Access Compliance Report

Public Rights-of-Way

Intersection ID: 12108	Main Street: CRESTMONT_DR	Cross Street: SHAMROCK_DR	Location: SW
ADA ID: 9563E9488658	Ramp Type: PerpDiag	Initial Pass/Fail: Fail	Overall Compliance: No
			Severity Score: 13.75

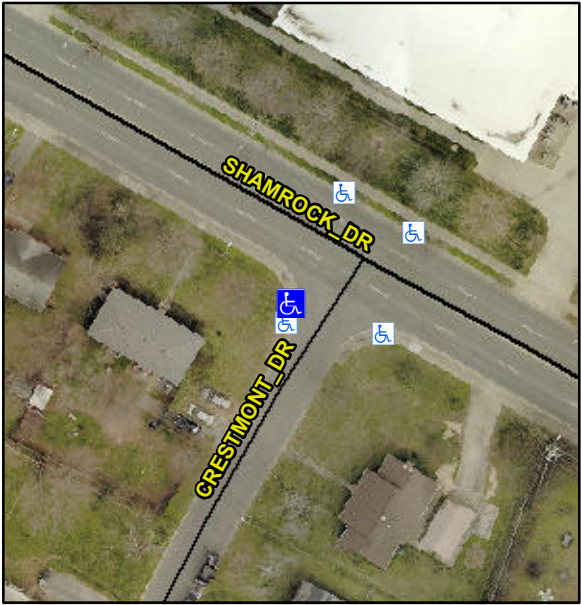
Codes/Mitigation Info/Possible Solution			Field Measurements/Component Compliance		
	Possible Solutions:		Compliance	Description	Data
	Remove & Replace Curb Ramp With Two New Directional Ramps or Equivalent.		No	Ramp Length (in)	56.0
			Yes	Ramp Width (in)	48.0
			N/A	Flare Type LT	N/A
			N/A	Flare Slope LT (%)	N/A
			N/A	Flare Traversable LT?	N/A
			N/A	Landing Length (in)	N/A
			N/A	Landing Width (in)	N/A
			N/A	Landing Slope (%)	N/A
			N/A	Landing X Slope (%)	N/A
<p>Surveyor Notes:</p> <p>N/A</p> <p>PROW/ADA:</p> <p>Not Found, R304.2.2, R304.5.3</p>			N/A	Flare Type RT	N/A
			N/A	Flare Slope RT (%)	N/A
			N/A	Flare Traversable RT?	N/A
			N/A	DWS Provided?	N/A
			N/A	DWS Contrast?	N/A
			N/A	DWS Length (in)	N/A
			N/A	DWS Full Width?	N/A
			N/A	DWS Offset (in)	N/A
			N/A	Gutter Ponding?	N/A
			N/A	Gutter Lip Ht (in)	N/A
			No	Painted X Walk1?	No
				X Walk 1 Direction	To SE
			N/A	X Walk 1 Width (in)	N/A

0.2	X Walk 1 Slope (%)	6.2
			3.6	X Walk 1 X Slope (%)	1.1
			N/A	Ramp inside XWalk1?	N/A
			3.4	Road Slope (%)	N/A
			9.0	Road X Slope (%)	N/A
			N/A	Any Obstructions?	N/A
				Obstruction Type	
			N/A	Clear Space?	N/A
			N/A	Clear Space to XWalk (in)	N/A
			N/A	Storm Grate/Utility Hazard?	N/A
				Storm Grate/Utility Type	
			N/A		N/A
			Yes	Surface Condition? (G/P)	Good
Total Cost:		\$ 3200.00
